Date: 24 February 2007
 To: T10 Technical Committee
 From: Ralph O. Weber
 Subject: Security Association Model for SPC-4

Figure x1 — SA relationships

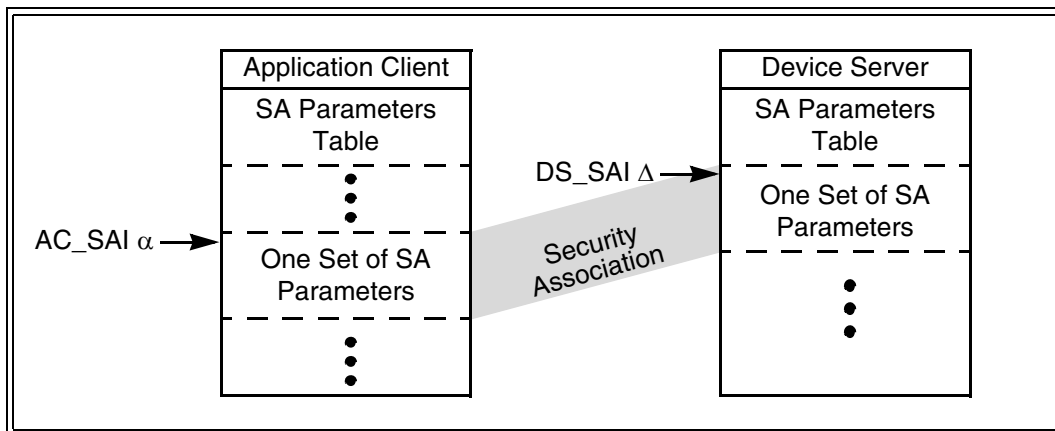
Figure x1 shows the relationship between application clients and device servers with respect to SAs.

In both the application client and the device server, the SA parameters are modelled as being stored in an indexed array and the SAI identifies one set of SA parameters within that array. The application client and device server are not required to store the parameters for any given SA in the same array locations. In order to support this implementation flexibility, a single SA is modelled as having two different SAI values (i.e., one for the application client and one for the device server).
